**PSE&G** Public Service  
Electric and Gas  
Company

August 20, 1984

HOPE CREEK GENERATING STATION  
DOCKET NO. 50-354  
DRAFT SAFETY EVALUATION REPORT  
OPEN ITEM STATUS

Attachment 1 is a current list which provides a status of the open items identified in Section 1.7 of the Draft Safety Evaluation Report (SER). Items identified as "complete" are those for which PSE&G has provided responses and no confirmation of status has been received from the staff. We will consider these items closed unless notified otherwise. In order to permit timely resolution of items identified as "complete" which may not be resolved to the staff's satisfaction, please provide a specific description of the issue which remains to be resolved.

FIGURE 220.21-33  
 RESPONSE SPECTRA COMPARISON,  
 AUXILIARY BUILDING AT ELEV. 178'-0",  
 VERTICAL, SSE, 2% DAMPING

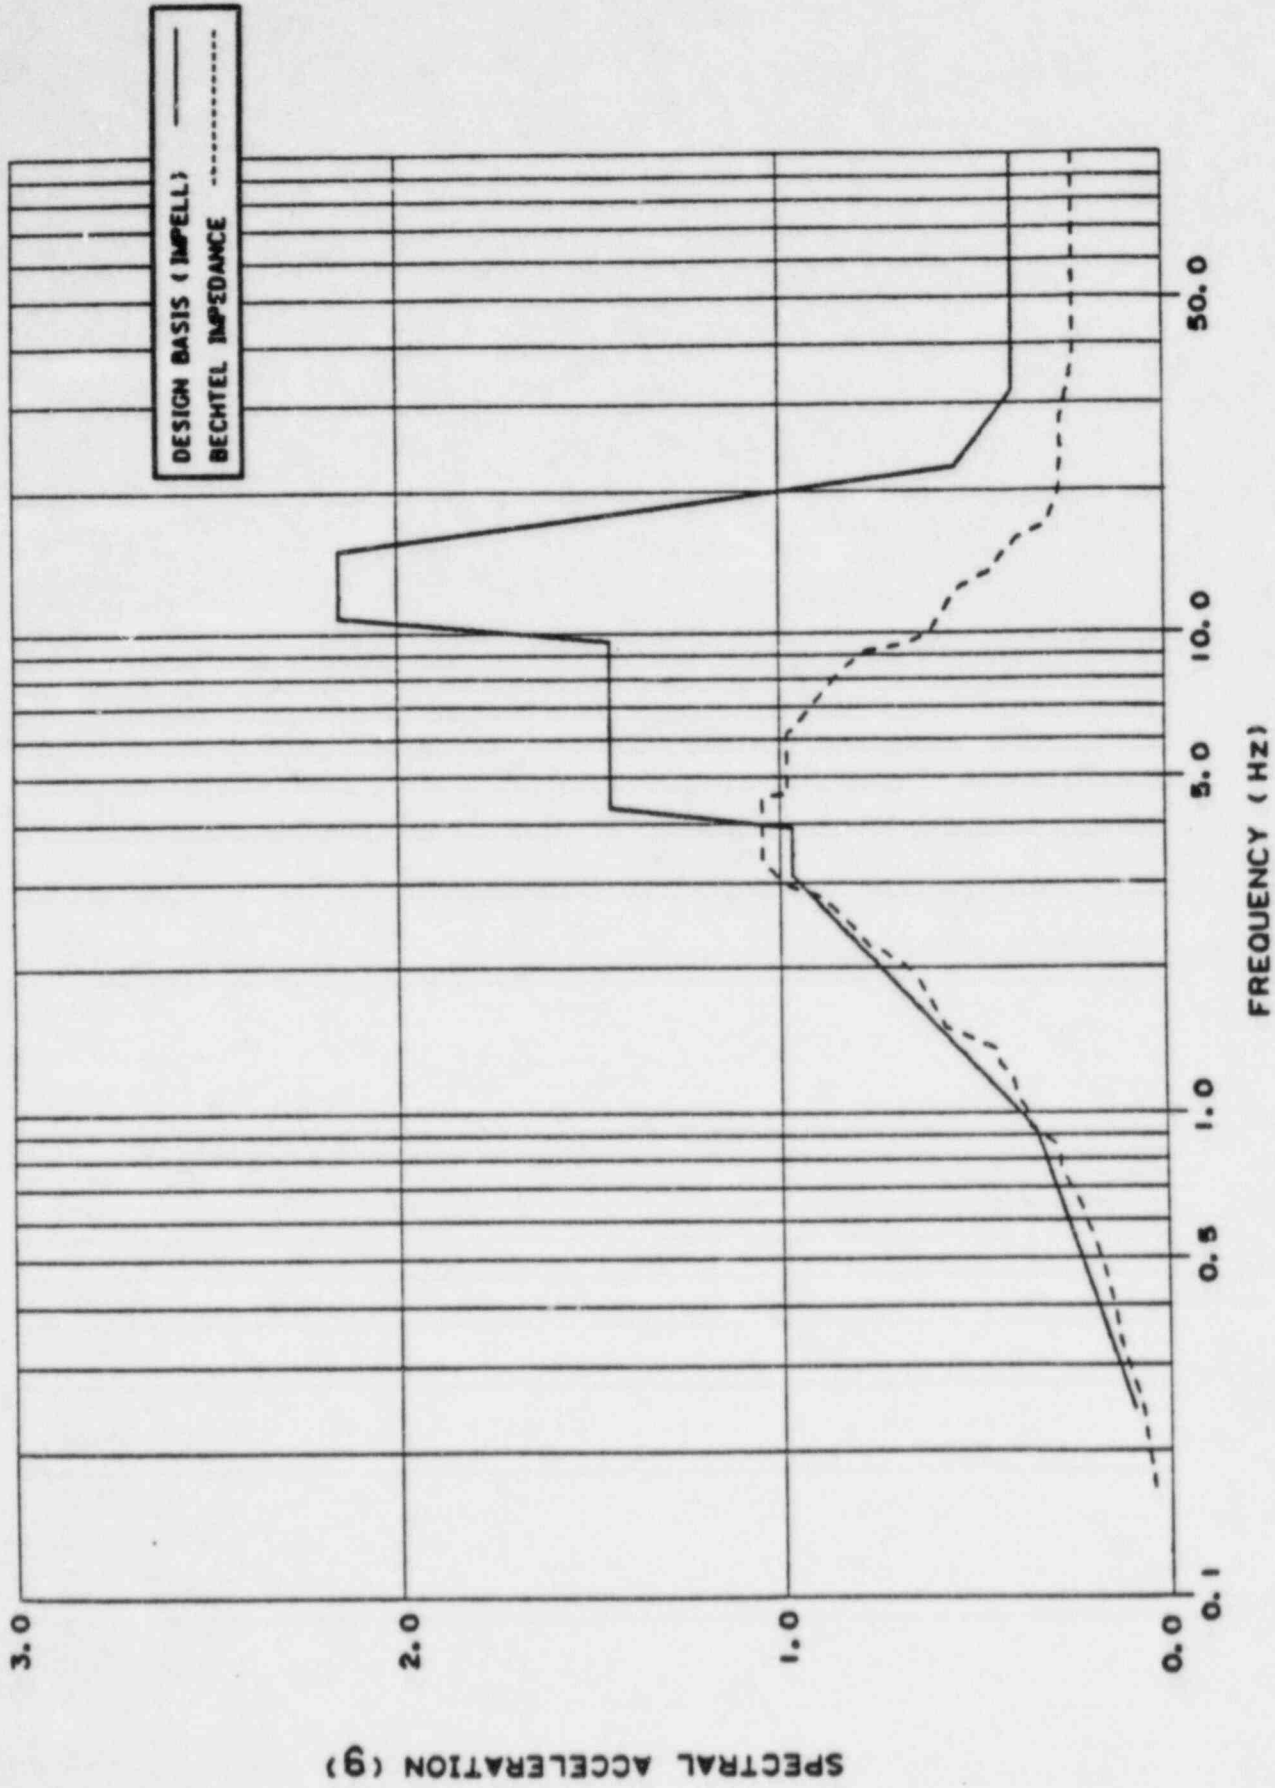
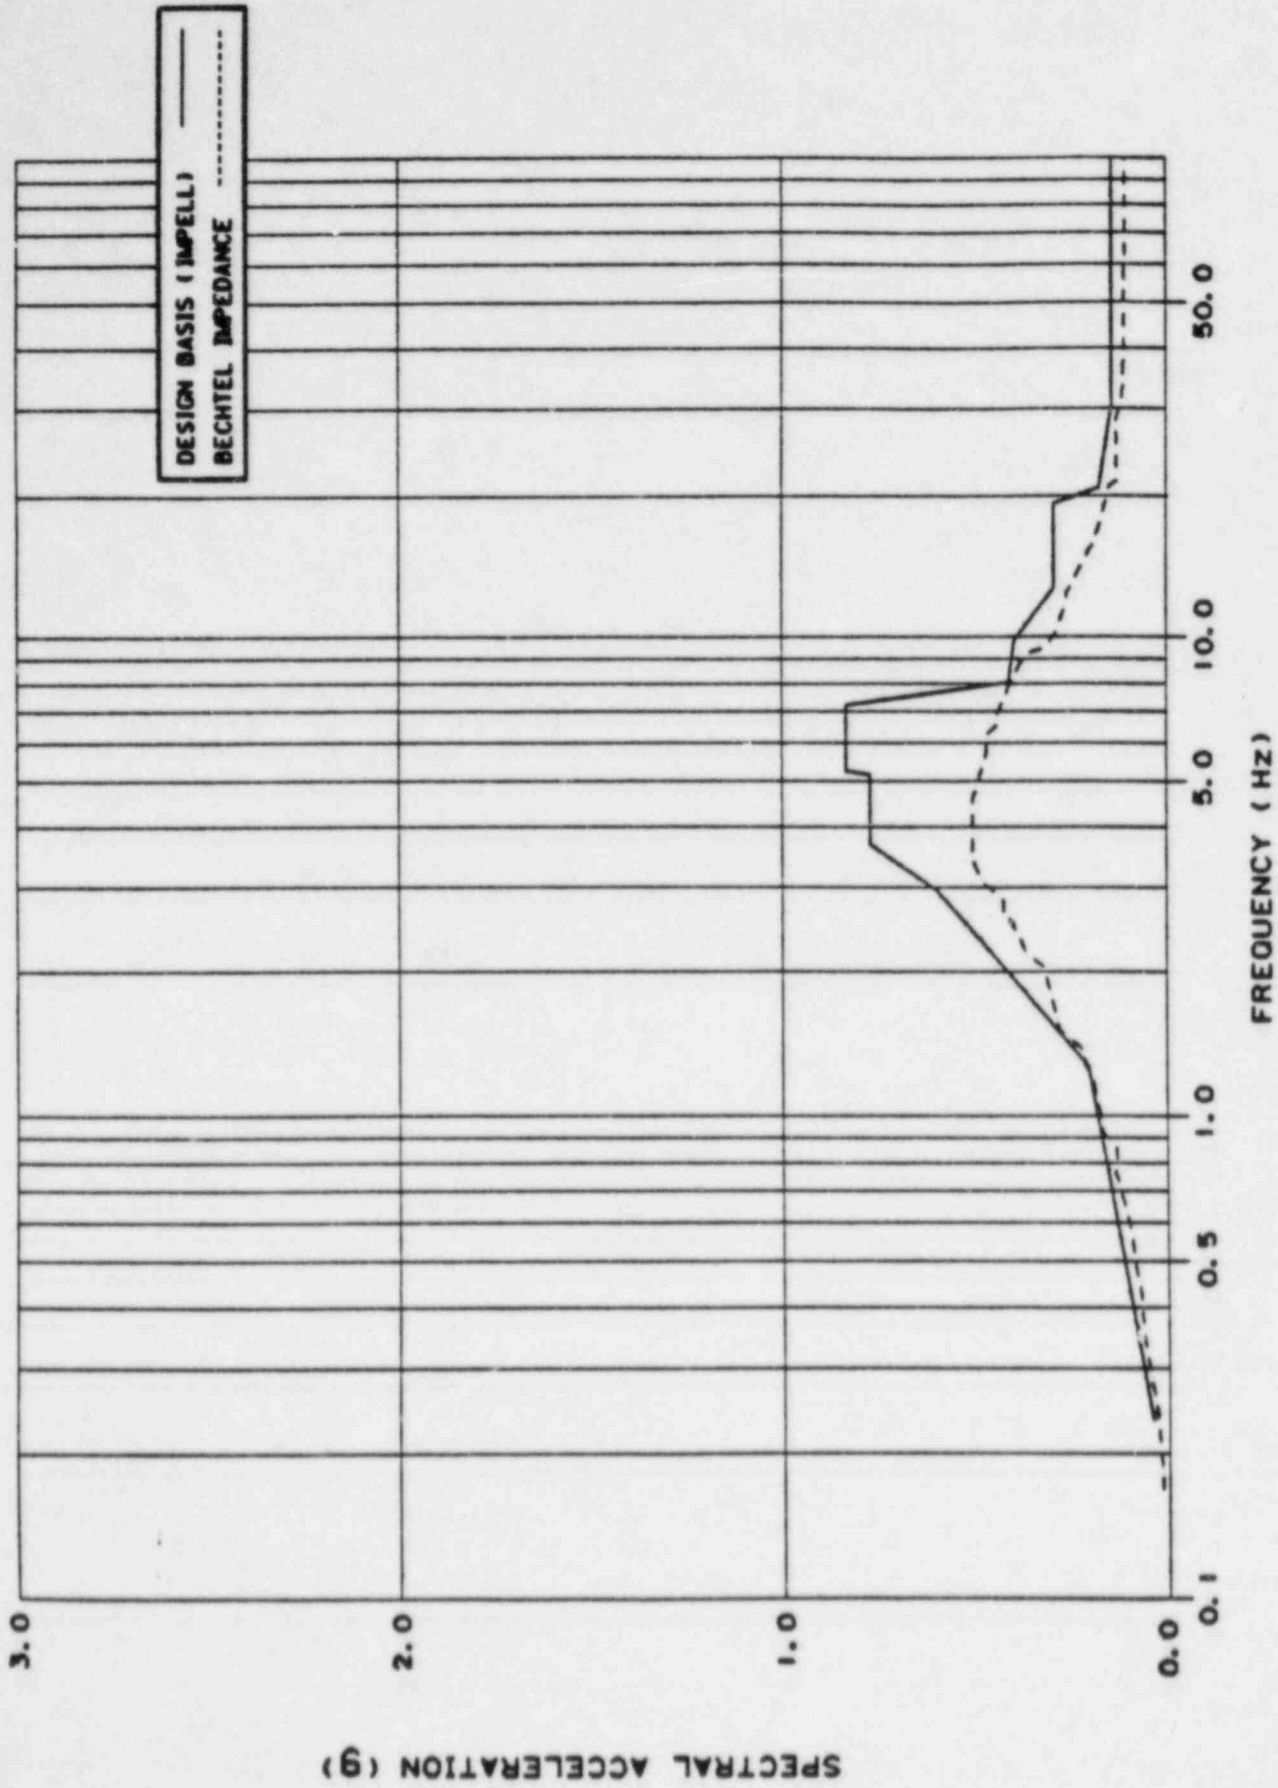
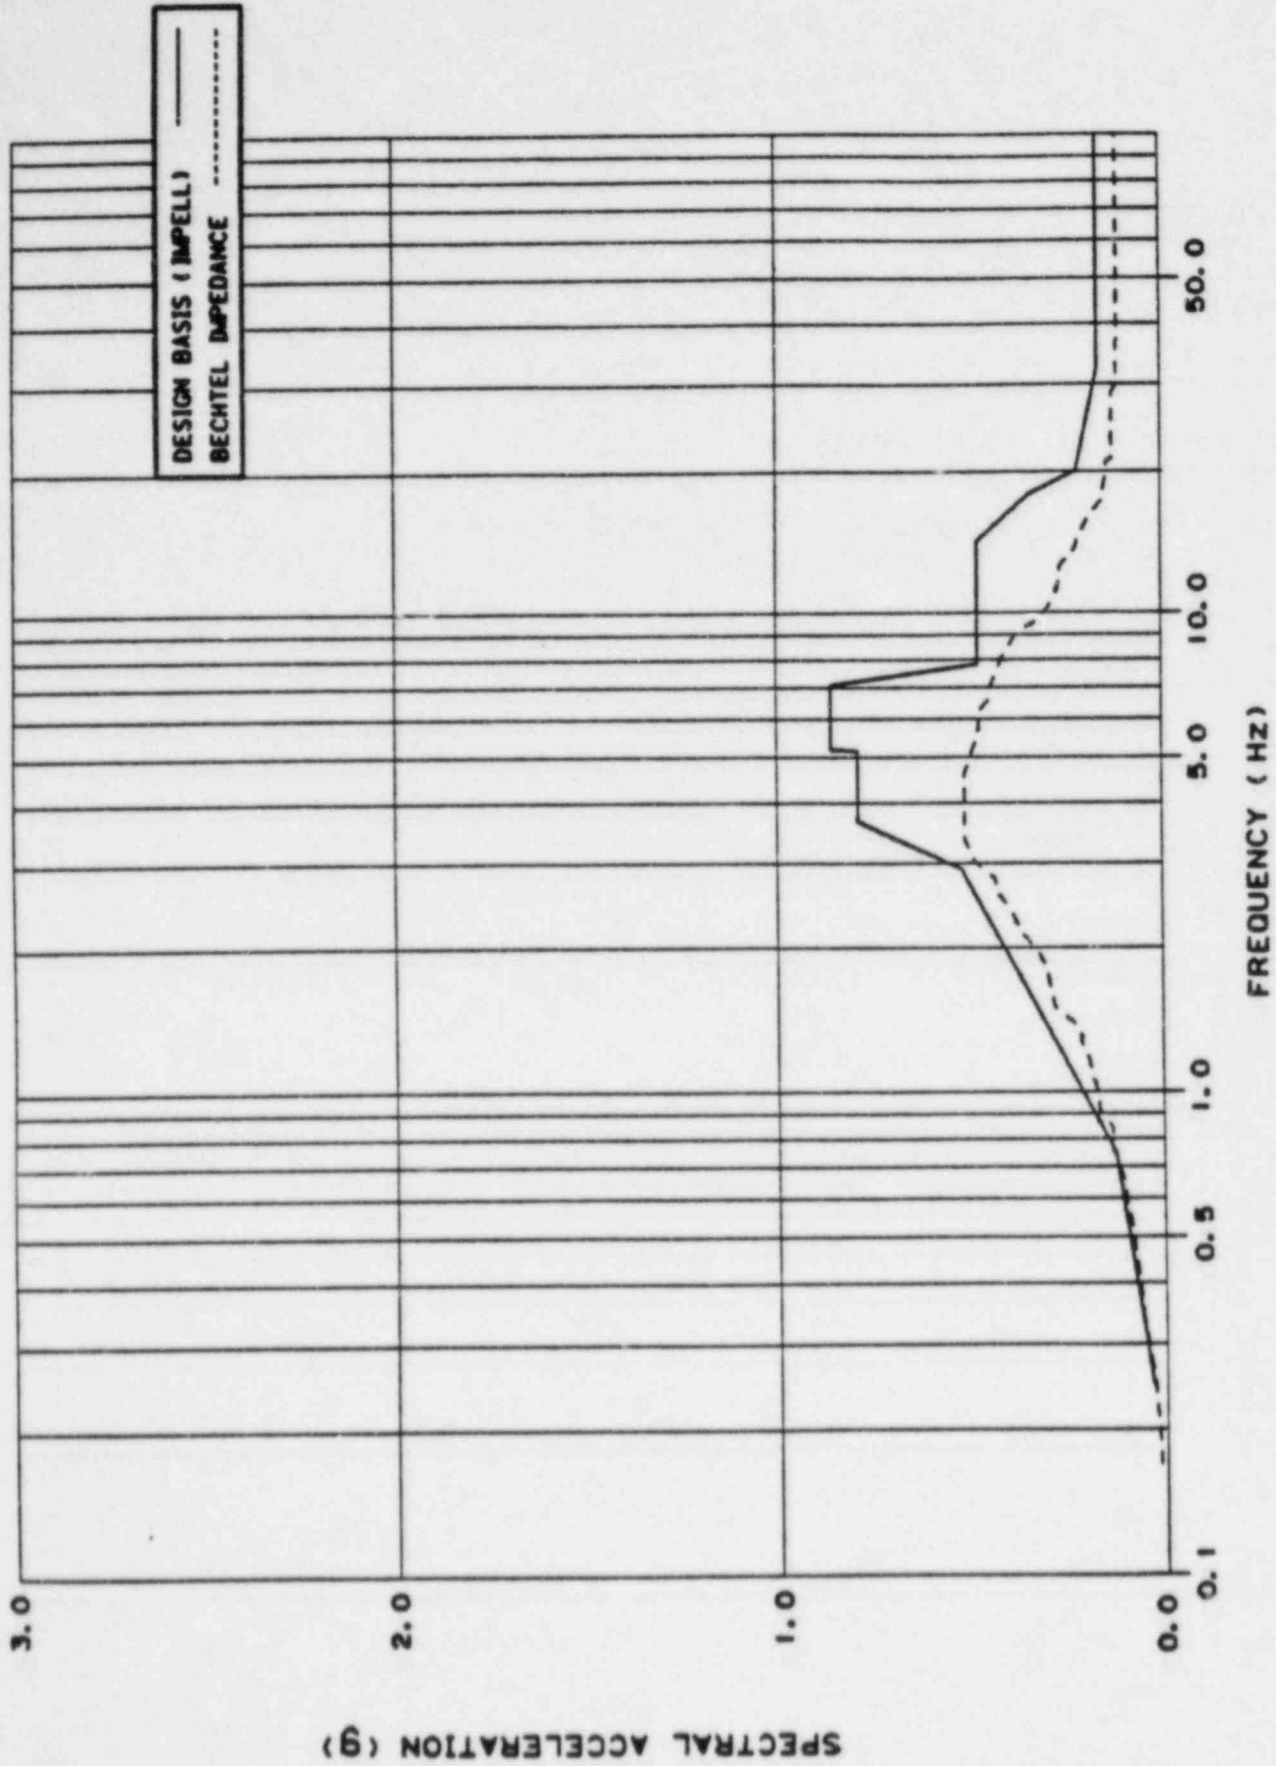
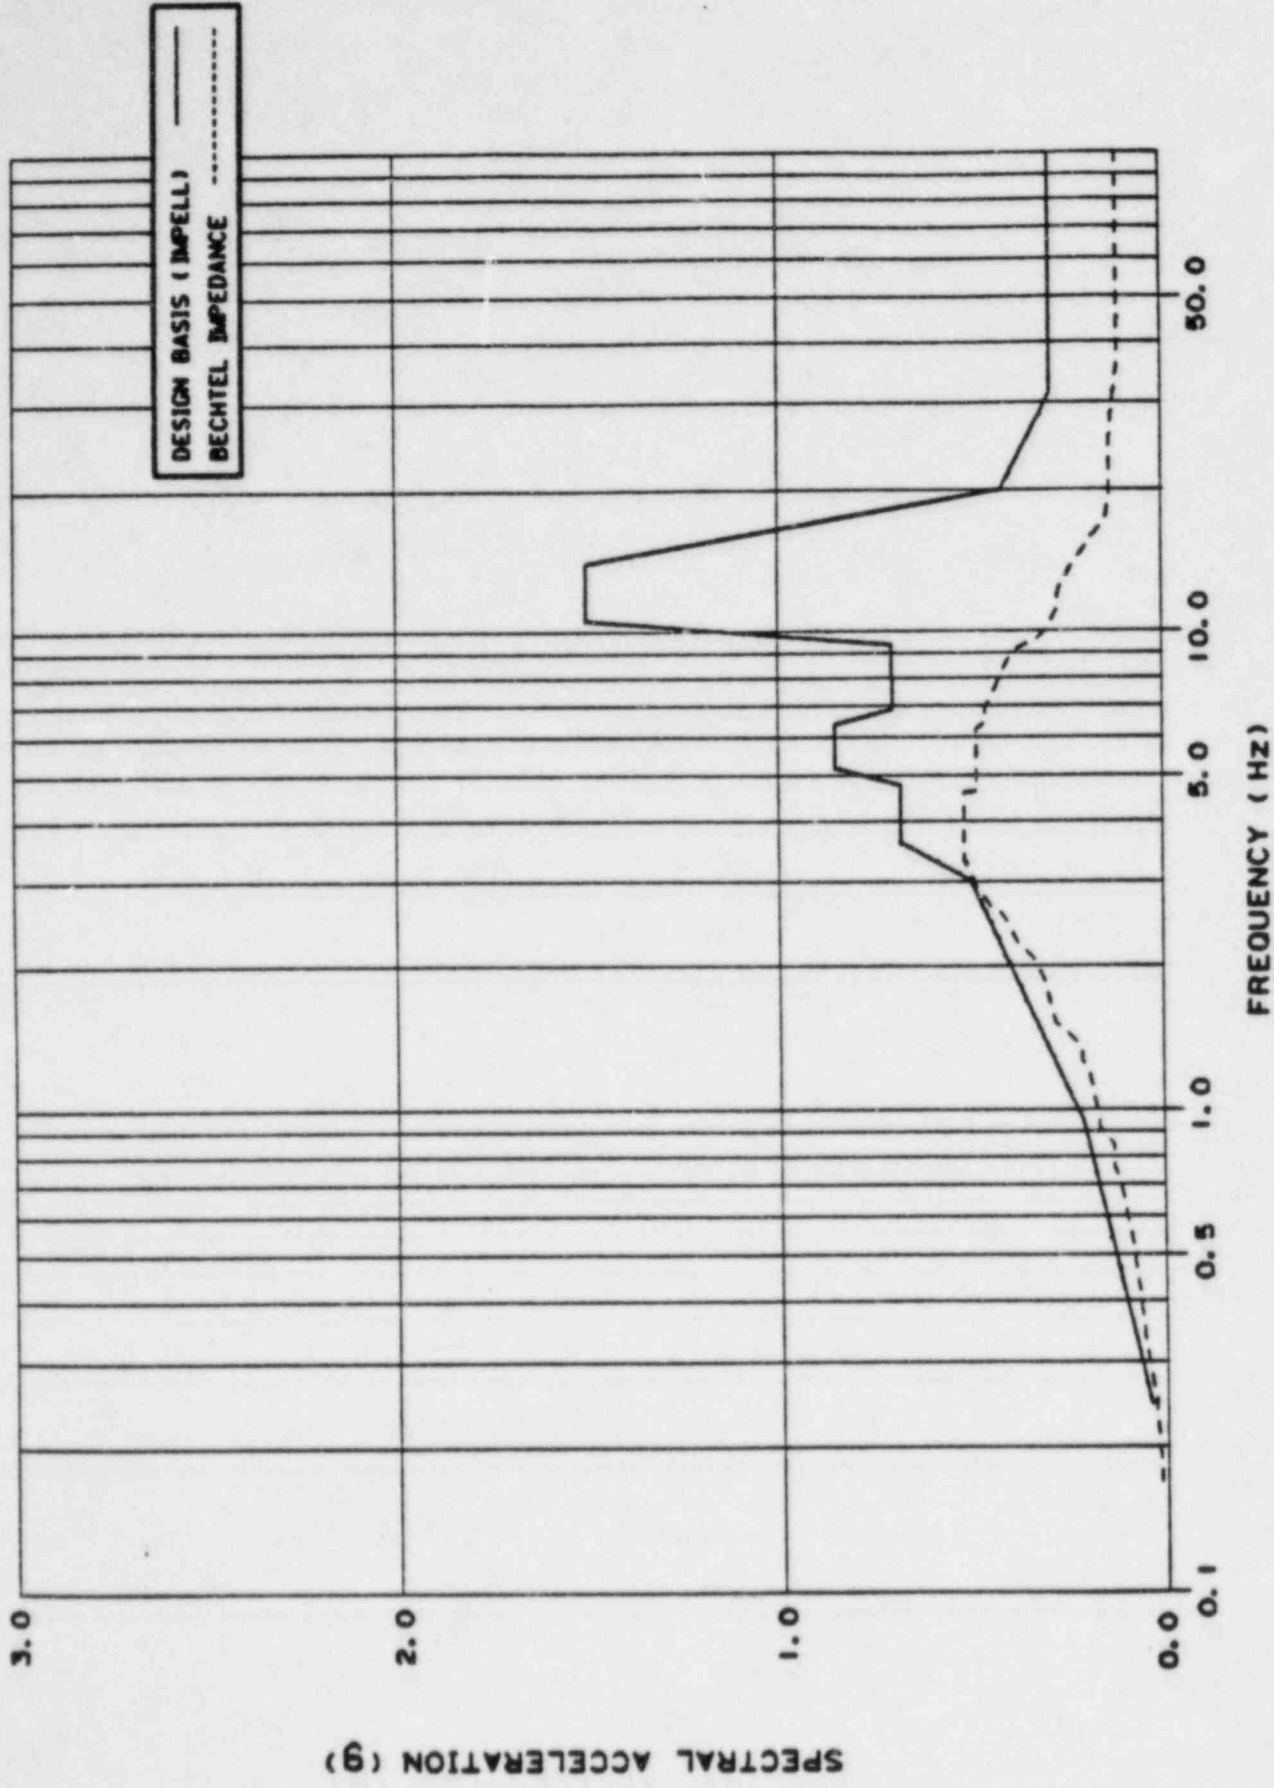
Figures 220.21-1 through 220.21-54 show a comparison of the 2 percent damping response spectra obtained from the design basis finite element and the impedance analyses for the reactor building, auxiliary building and the service water intake structure (SWIS).

¶ For the reactor and auxiliary buildings, the peak spectral accelerations obtained from the impedance analysis are generally lower than those obtained from the design basis analysis. However, the impedance analysis response spectra are not completely enveloped by those obtained from the design basis analysis, especially in the frequency range from 1.0 to 3.5 Hz. Also, there are some local exceedances in the higher frequency range, as shown in Figures 220.21-1 through 220.21-36. ¶ For the SWIS (Figures 220.21-37 through 220.21-54), the impedance analysis response spectra are generally enveloped by those obtained from the design basis analysis at elevation 114.0 feet. For other elevations, the impedance analysis spectral accelerations exceed the design basis spectral accelerations in some frequency ranges. These ranges vary approximately between 1.5 and 10.0 Hz.

In all cases, the items reviewed during these sampling studies can accommodate the loads resulting from the impedance analysis. Therefore, the impedance analysis results have no impact on the plant design.
